UNITED STATES PATENT AND TRADEMARK OFFICE

Office Action Summary

10/581,195

DETAILED ACTION

FIG. 12

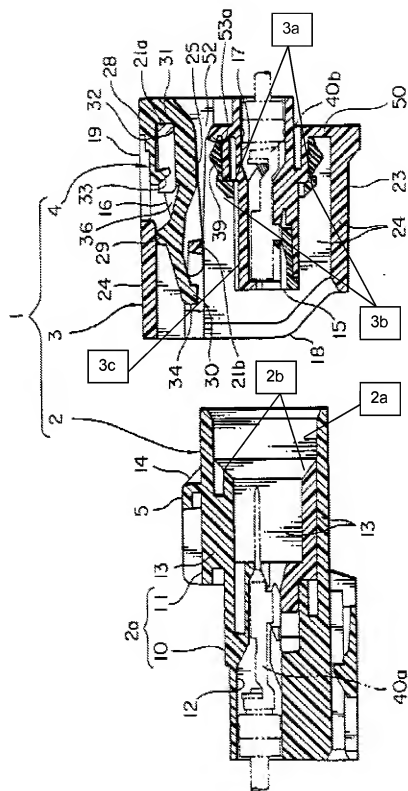
Regarding claim 3, Fukuda, fig. 1-22, discloses an electrical connector 1 comprising: a first female connector housing 2, and a second male connector housing 3 mating with the first female connector housing, the first female connector housing having a male connector housing space 2a with a first peripheral wall 13, the second male connector housing having an inner housing 15 with a second peripheral wall 3c, wherein a tapered surface 2b is integrally formed on one of an inner surface of the first peripheral wall of the first female connector housing, and a projection 3a from an outer surface, positioned at a forward end of the second peripheral wall, of the second male connector housing, the tapered surface inclined in the mating direction of the first female and second male connector housings, the tapered surface engaged with a surface of the other connector housing on mating of the first female and second male connector housings.

Regarding claim 4, Fukuda discloses the tapered surface is unitarily formed with the one of connector housings.

Regarding claim 6, Fukuda discloses the second male connector housing has the inner housing formed with a looseness prohibiting protrusion 3a, wherein the tapered surface of the first female connector housing abuts against the looseness prohibiting protrusion on mating the first female and second male connector housings.

Regarding claim 7, Fukuda discloses the looseness prohibiting protrusion has a tapered surface engaged with the tapered surface of the first female connector housing to define a surface-contact state.

Regarding claim 8, Fukuda discloses the inner housing is movable in the connector mating direction and is urged toward the first female connector housing by a resilient member 39.

Regarding claim 9, Fukuda discloses the resilient member is a waterproof packing attached in the second male connector housing, the waterproof packing closely sandwiched between an outer surface of the peripheral wall of the inner housing and an inner surface of the peripheral wall of the first female connector housing on complete engagement of the first female and second male connector housings.

4. Applicant's arguments filed on November 16, 2008 have been fully considered but they are not persuasive. The Applicant argues "The surface (3b), referred to in the sketch on page 3 of the Office Action, is on an end of the packing (39) that provides a seal in the male housing (3) and is not integrally formed on the housing as required in the present invention." And also "while there may be some contact between identified tapered surfaces (2b) and (3b) in assembly of the connector, these surfaces do not engage with each other on "complete" mating of the two housings." The Examiner respectfully disagrees. As shown clearly in FIG. 4 of Fukuda, the tapered surfaces of housing 3 are not part of the packing (39) but part of wedge like element 3a of the housing 3. And as shown in FIG. 16 of Fukuda (lower part) tapered surfaces of the housing 2 and housing 3 engage with each other (otherwise there is no another purpose of making these surfaces tapered correspondingly each other).
